Re: **Interim Remedial Action Plan – Addendum No. 2**  
Connell Automotive Dealership  
3093 Broadway  
Oakland, California  
StID #469

Re: **Connell Automobile Dealership --  
Addendum to Interim Remedial Action Plan**  
3093 Broadway  
Oakland, California

Re: **Addendum to Interim Remedial Action Plan**  
Connell Automotive Dealership  
3093 Broadway  
Oakland, California  
StID #469

Figure  
**5A**

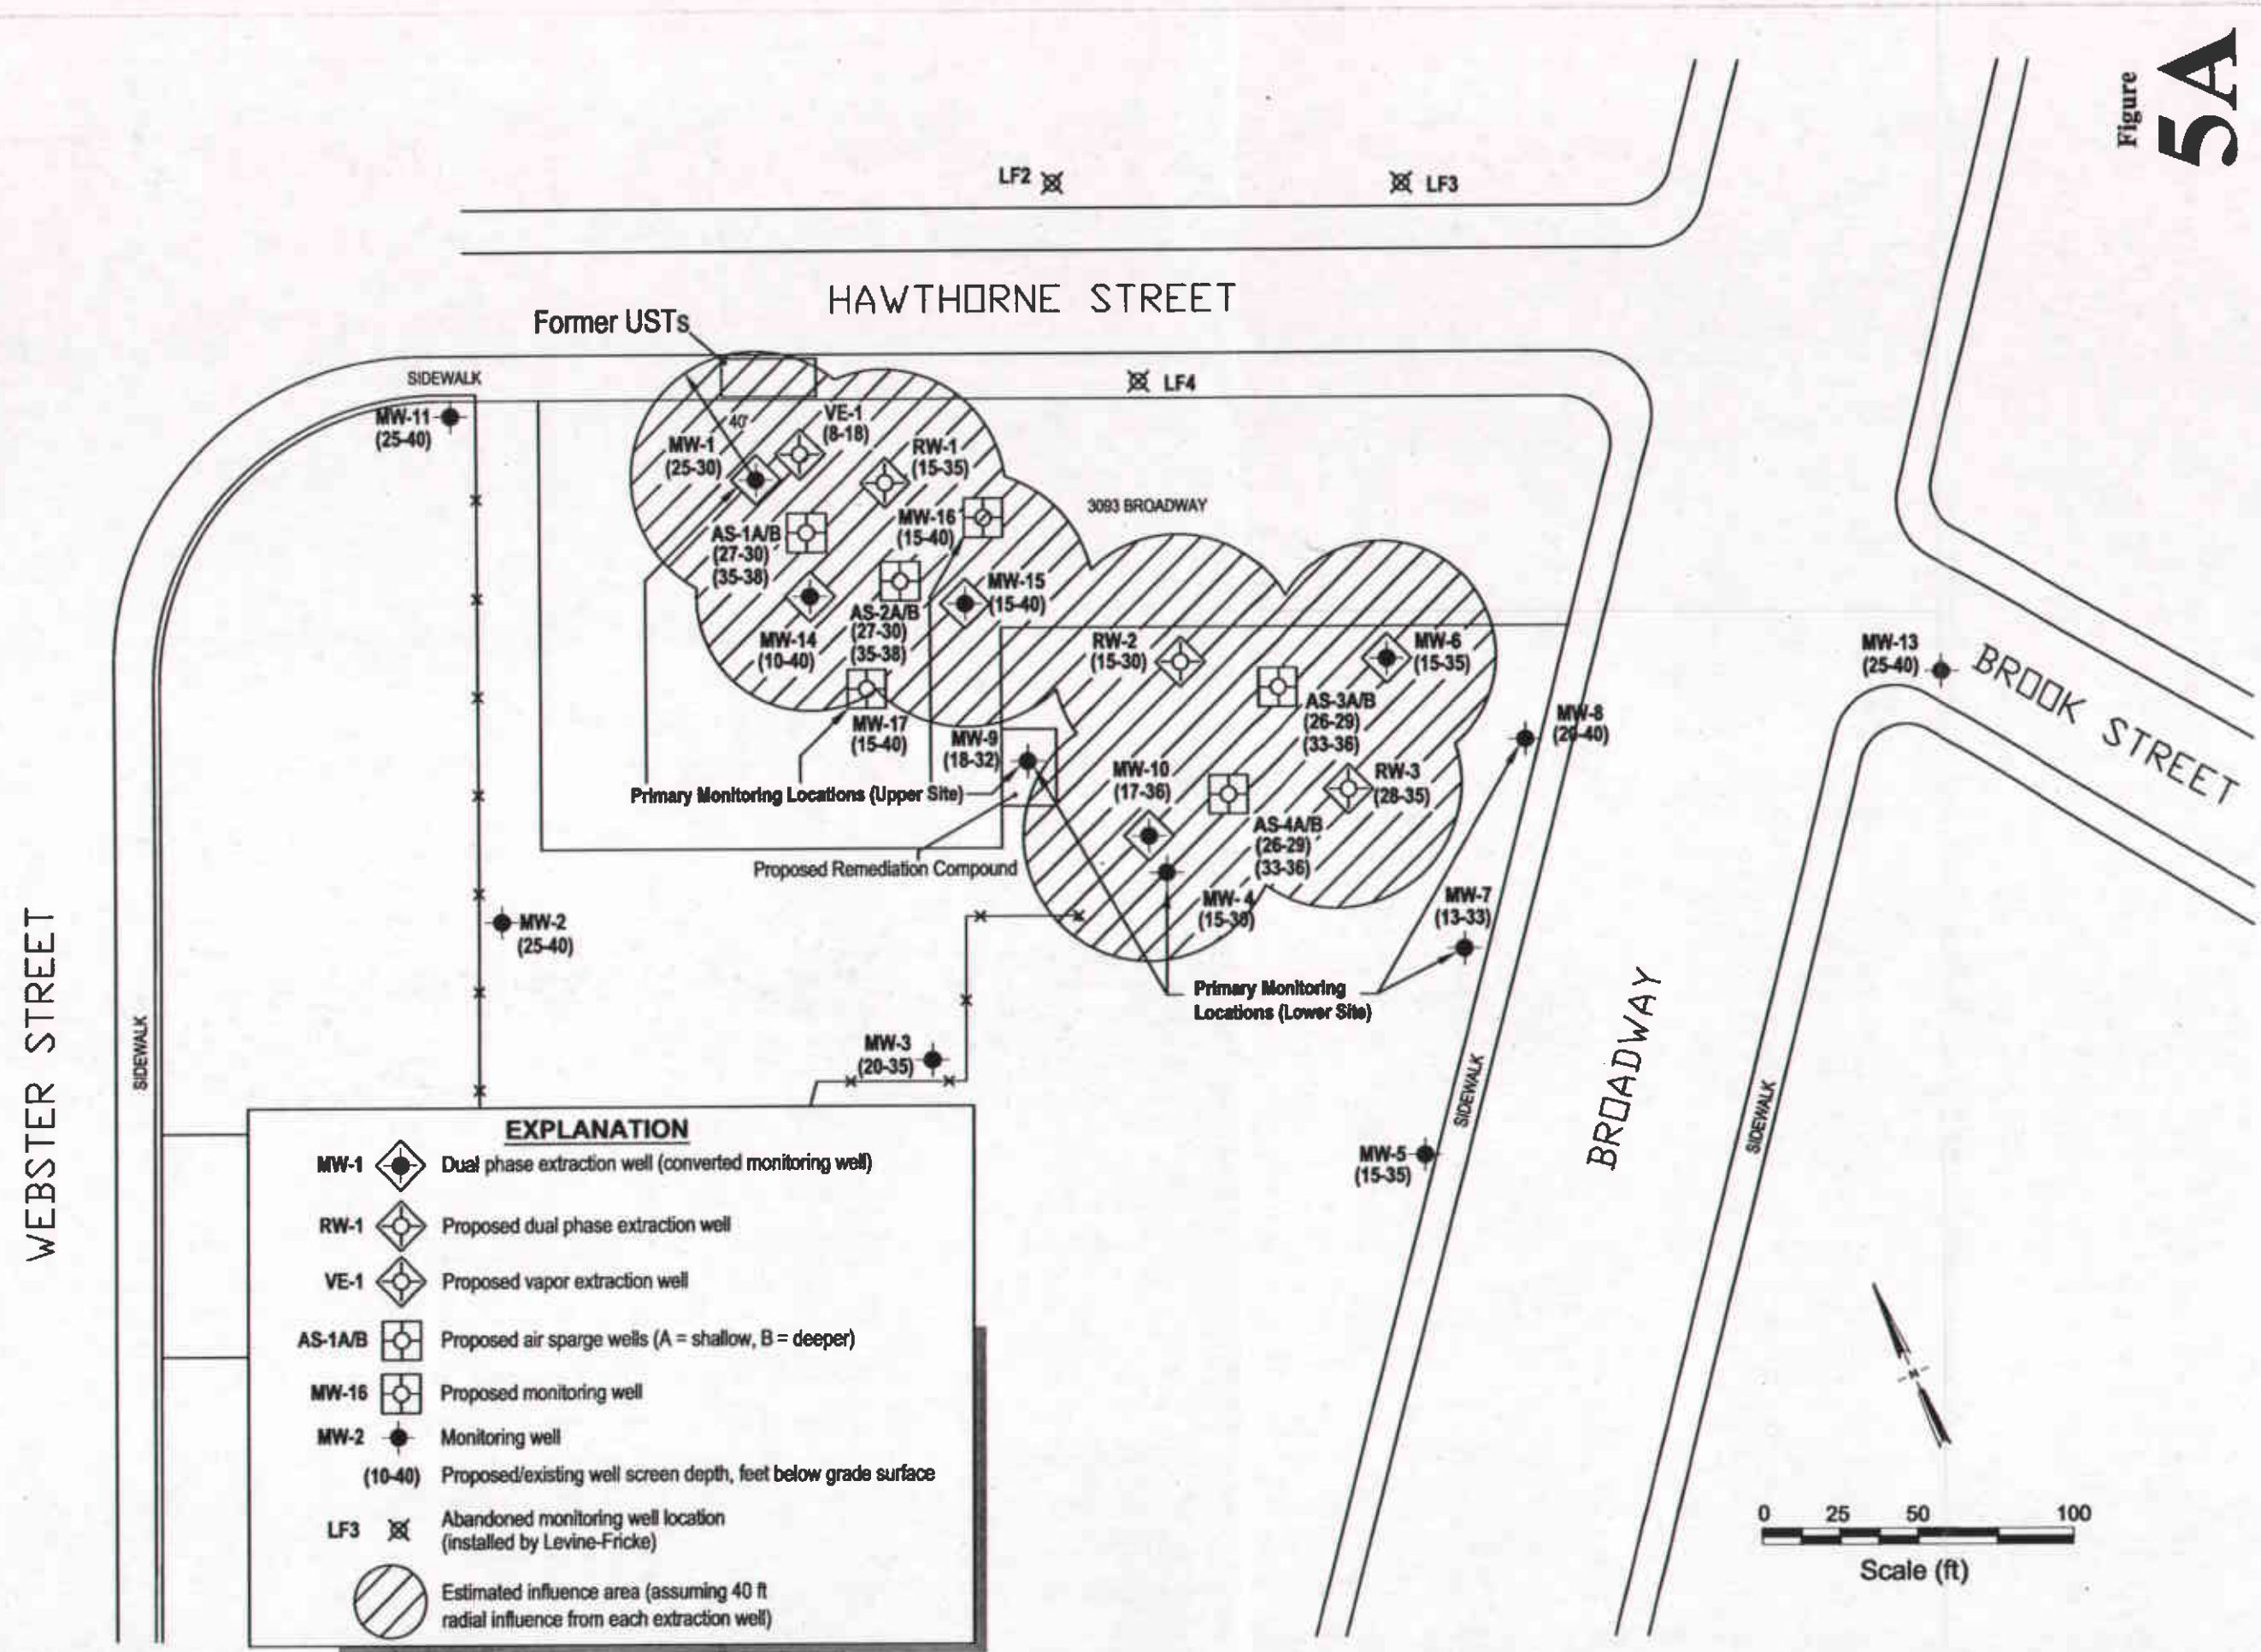
**Comment #3 – With many Site Wells converted to Extraction Wells, is the proposed well network sufficient to monitor remedial effectiveness and any lateral migration of dissolved contamination and free product?**

In response to ACEH concerns, Pangea proposes three additional wells at the upper portion of the site. Wells MW-16 and MW-17 are proposed for monitoring the lateral extent of groundwater during site remediation. These two wells will be screened from 15 to 40 ft bgs, similar to existing wells MW-14 and MW-15. Well VE-1 is proposed adjacent to well MW-1. This well will allow vapor extraction from VE-1 with groundwater monitoring from nearby MW-1 (MW-1 will be used intermittently for monitoring and extraction).

The proposed system layout is shown on Figure 5A. Figure 6 is a cross section illustrating the proposed well screens, estimated hydrocarbon distribution, and initial extraction/sparge areas.

6

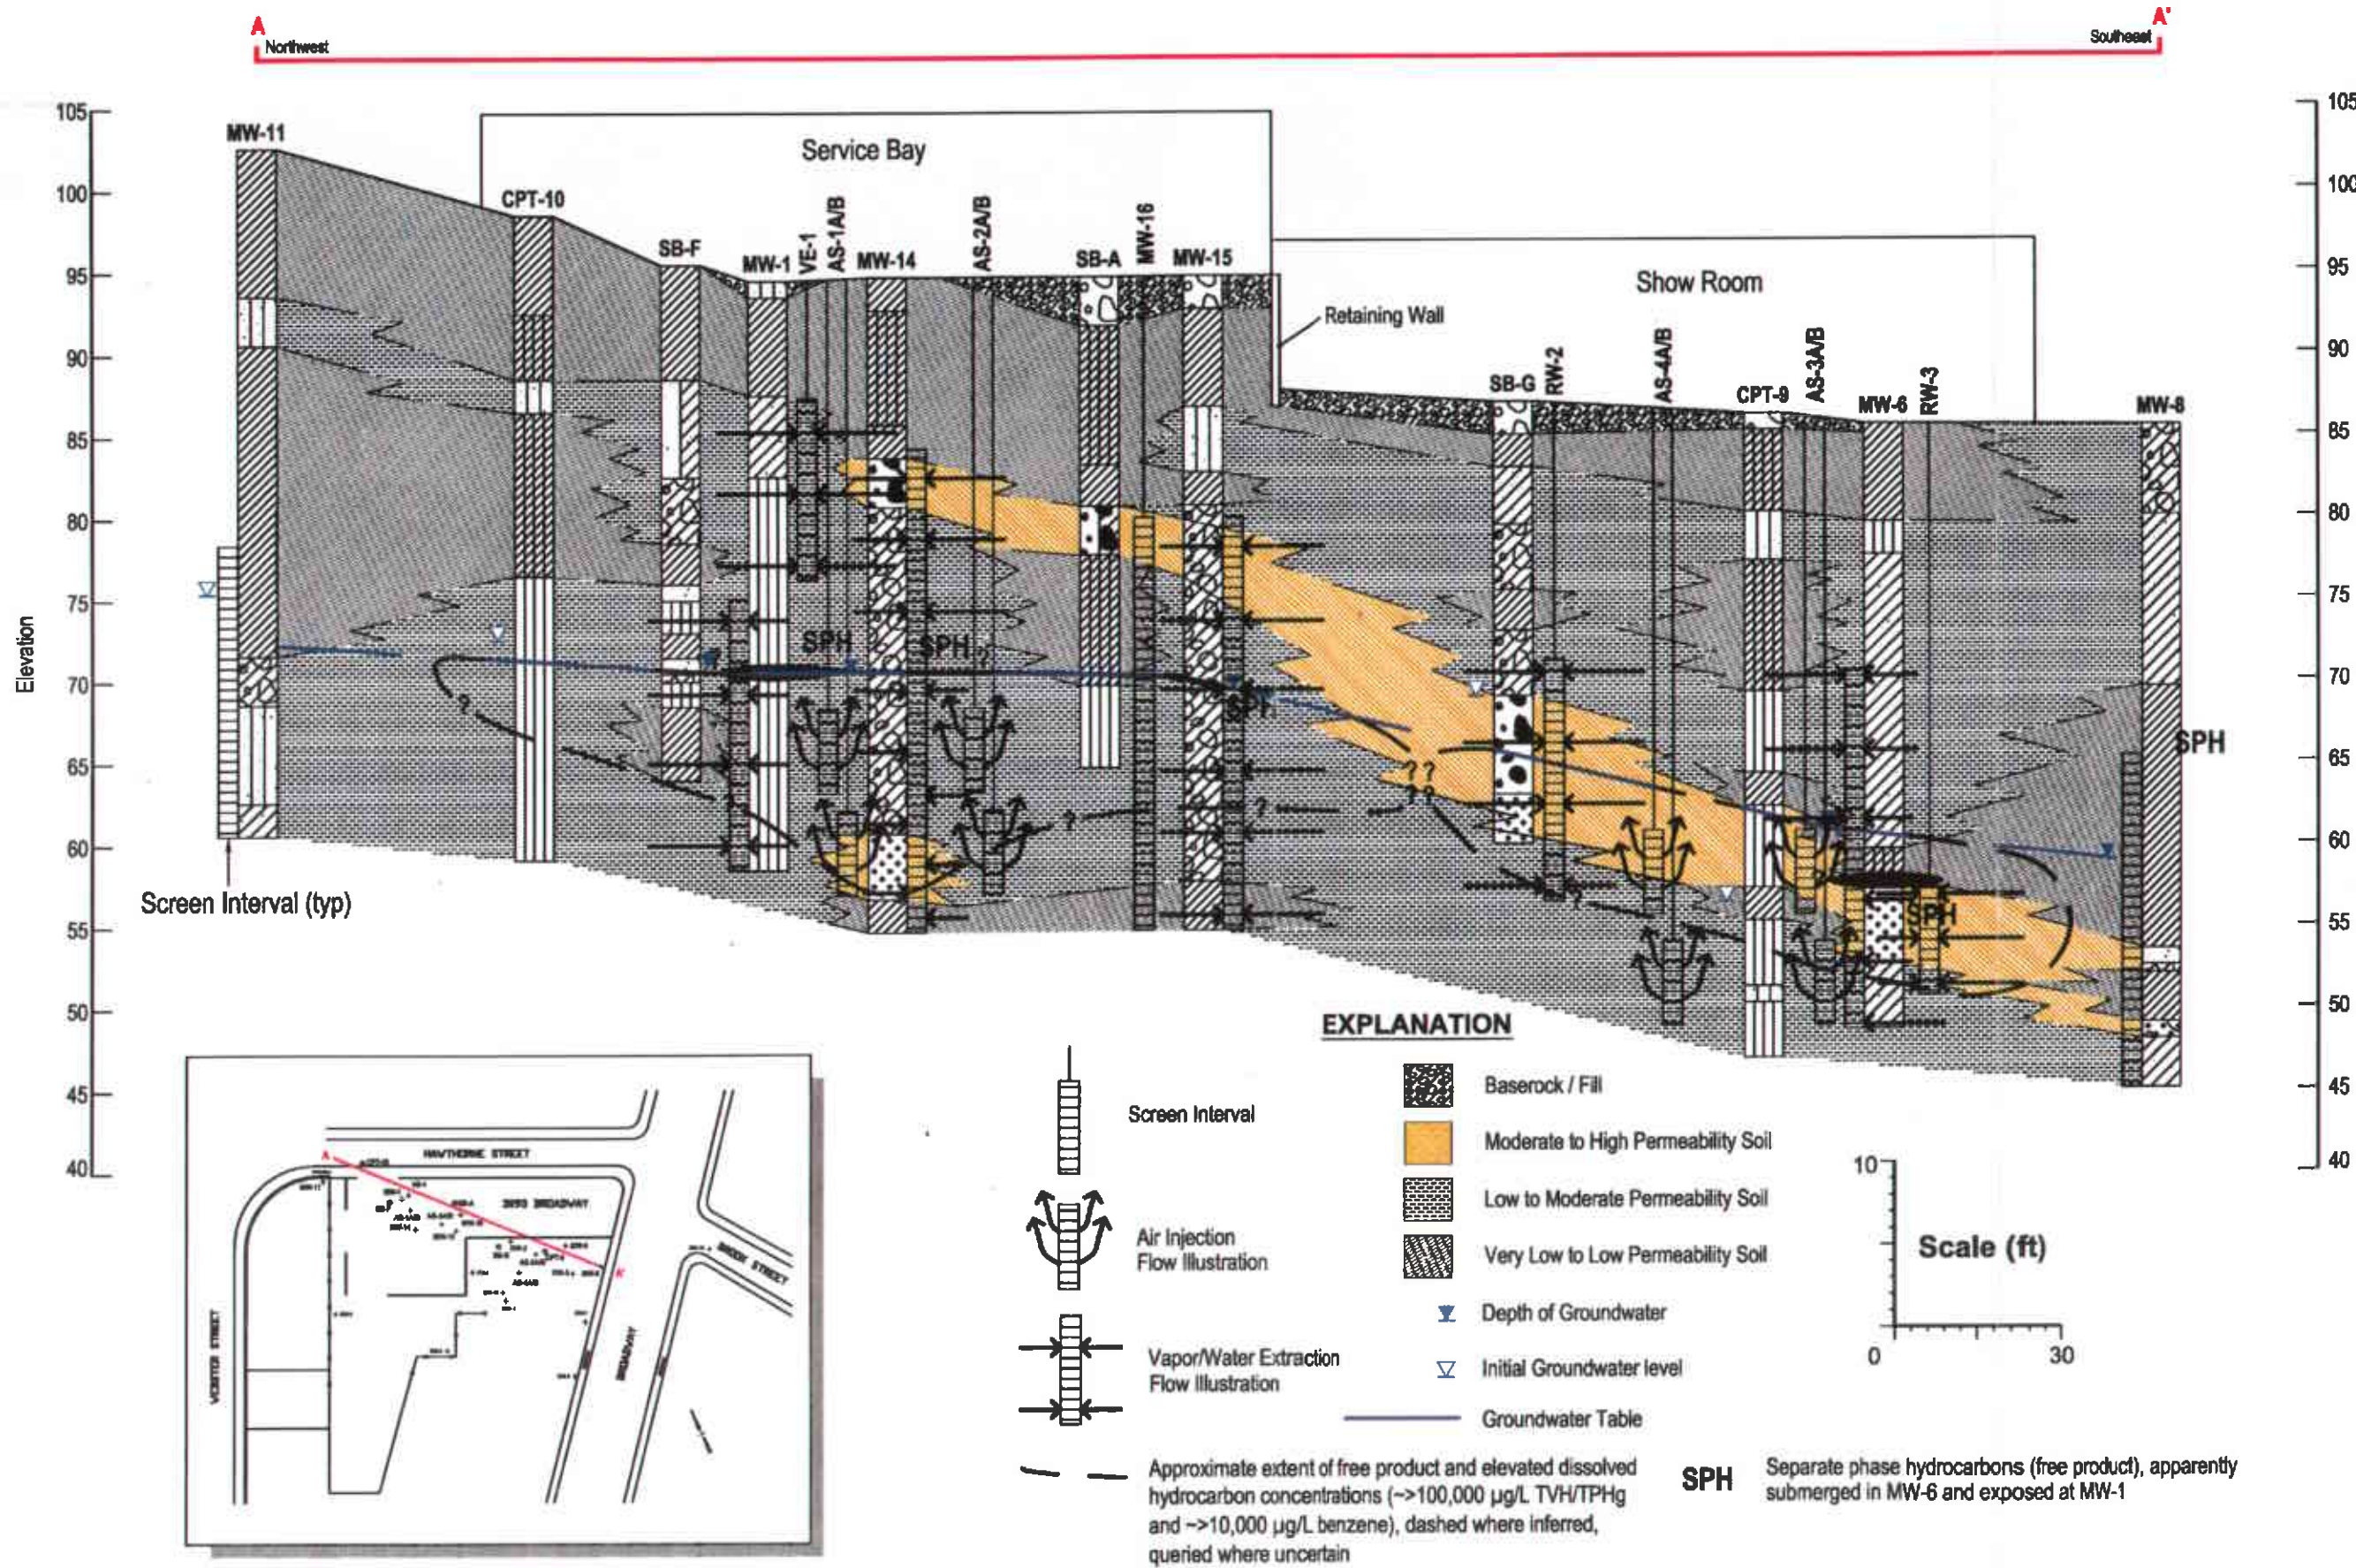
*The ACEH was specifically concerned about well MW-1 where 5,500 mg/kg TPHg and 16.3 mg/kg benzene were detected at 30.5 ft below grade surface (bgs). The ACEH also mentioned concern about vertical contamination at well MW-14. The ACEH wondered if the air sparging wells were deep enough in the upper portion of the site.*

In response to this concern, Pangea prepared Figure 6 to illustrate the proposed wells and approach for targeting the vertical extent of contamination. The vertical extent of contamination at MW-1 was adequately defined by the deeper sample at 34.5 ft bgs, where no benzene and only 2 mg/kg TPHg was detected. Nearby boring B-1 (located beneath the former UST excavation) delineated soil down to 43 ft bgs, where no TPHg and trace BTEX concentrations were detected. No TPHg or BTEX was detected in soil from borings for wells MW-14 and MW-15, except for trace BTEX concentrations at 21 ft bgs in well MW-14. The boring log for MW-14 indicated strong hydrocarbon odor at 20 ft bgs, but did not mention odors at greater depths. While heaving sands at 34 ft bgs in well MW-14 prevented sample collection at this depth or deeper, the proposed air sparge wells will further define deeper conditions (and will facilitate their remediation if significantly impacted).

Pangea finds that the vertical extent of contamination is adequately defined, and that sampling during installation of the proposed wells will help confirm this conclusion. Prior investigation results suggest that the hydrocarbon mass at the upper portion of the site is primarily located at depths ranging from approximately 23 to 30 ft bgs. This impact depth will be targeted by dual-phase extraction from well MW-1 (screened from down to 35 ft bgs), well MW-14 (screened from 10 to 40 ft bgs), well MW-15 (screened from 15-40 ft bgs), and well RW-1 (to be screened from 15 to 35 ft bgs). The impact depth will also be targeted by the proposed air sparge wells, which will be deep enough to target known contamination. Wells AS-1A and AS-2A will target the capillary fringe and shallower groundwater, and will be screened from 27-30 ft bgs in shallower clayey gravel. Wells AS-1B and AS-2B will target deeper groundwater and will be screened from 35 to 38 ft bgs, which may be in the well-graded sand unit found during installation of well MW-14.
